Access Compliance Report

Public Rights-of-Way

(Pedestrian Signals)

Intersection ID: N/A	Main Street:	Cross Street: N/A	Location: N/A
ADA ID: 58EC6A804C8D	Signal Type: Two Push Buttons-Non APS	Overall Compliance: No	Severity Score: BTN 1:N/A BTN 2: N/A No BTN: N/A
Codes/Mitigation Info/Possible Solution		Field Measurements/Component Compliance

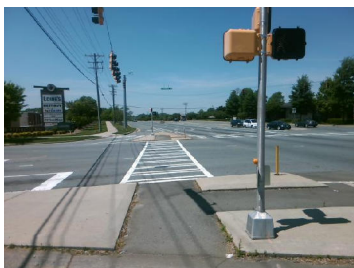
Surveyor Notes: B1 SIGN ARROW GOES WEST & S. EAST

PROW/ADA: TMUTCD 4e.08, R404.2, R404.3, R406.2, R404.7.3, R404.7.1, R404.7.2

Compliance	Description	Data	Compliance	Description	Data
	Button Count	Button2	N/A	Distant to Additional Button (in)	N/A
	Additional Button Present?	No		Additional Button ID	N/A
N/A	Signal Buttons Required?	N/A	N/A	Additional Ped Posts Required	N/A
	How Many Ped Street Xings?	3		Located In An Island/Median?	Yes
N/A	B 1 Sign Present?	Yes	N/A	B 2 Sign Present?	Yes
Yes	B 1 Sign Purpose?	Yes	Yes	B 2 Sign Purpose?	Yes
Yes	B 1 Sign Lettering & Contrast?	Yes	Yes	B 2 Sign Lettering & Contrast?	Yes
Yes	B 1 Parallel To XWalk?	Yes	Yes	B 2 Parallel To XWalk?	Yes
Yes	B 1 PAR to Button?	Yes	Yes	B 2 PAR to Button?	Yes
Yes	B 1 PAR to XWalk?	Yes	Yes	B 2 PAR to XWalk?	Yes
Yes	B 1 Clear Floor Space?	Yes	Yes	B 2 Clear Floor Space?	Yes
N/A	B 1 FWD Approach?	Yes	No	B 2 FWD Approach?	No
N/A	B 1 FWD Approach Constrained?	No	N/A	B 2 FWD Approach Constrained?	No
No	B 1 FWD Approach Reach (in)	12.0	N/A	B 2 FWD Approach Reach (in)	49.0

N/A	B 1 FWD Approach Width (in)	N/A	N/A	B 2 FWD Approach Width (in)	N/A
N/A	B 1 FWD Approach Obstruction?	Yes	N/A	B 2 FWD Approach Obstruction?	No
N/A	B 1 FWD Approach Obstruction Dist (in)	6.0	N/A	B 2 FWD Approach ObstructionDist (in)	4.0
N/A	B 1 PARA Approach?	Yes	No	B 2 PARA Approach?	No
N/A	B 1 PARA Approach Constrained?	No	N/A	B 2 PARA Approach Constrained?	No
No	B 1 PARA Approach Reach (in)	12.0	N/A	B 2 PARA Approach Reach (in)	49.0
N/A	B 1 PARA Approach Width (in)	60.0	N/A	B 2 PARA Approach Width (in)	60.0
N/A	B 1 PARA Approach Obstruction?	Yes	N/A	B 2 PARA Approach Obstruction?	Yes
N/A	B 1 PARA Approach Obstruction Dist (in)	6.0	N/A	B 2 PARA Approach ObstructionDist (in)	4.0
No	B 1 Clear Floor Space Slope (%)	3.4	No	B 2 Clear Floor Space Slope (%)	4.2
No	B 1 Clear Floor Space XSlope (%)	3.9	Yes	B 2 Clear Floor Space XSlope (%)	1.4
N/A	B 1 PAR Slope (%)	0.9	N/A	B 2 PAR Slope (%)	1.1
Yes	B 1 Height (in)	48.0	Yes	B 2 Height (in)	48.0

Yes	B 1 Clear Xing Direction?	ClearlyMarked	Yes	B 2 Clear Xing Direction?	ClearlyMarked
	B 1 Crossing Direction	To W		B 2 Crossing Direction	To N
Yes	B 1 DistanceTo XWalk (in)	0.0	Yes	B 2 DistanceTo XWalk (in)	39.0
No	B 1 DistanceTo Curb (in)	12.0	No	B 2 DistanceTo Curb (in)	12.0
Yes	B 1 Diameter (in)	2.0	Yes	B 2 Diameter (in)	2.0

Possible Solutions: Replace Signal Push Button With APS Button on New Post. Remove & Relocate Sign.
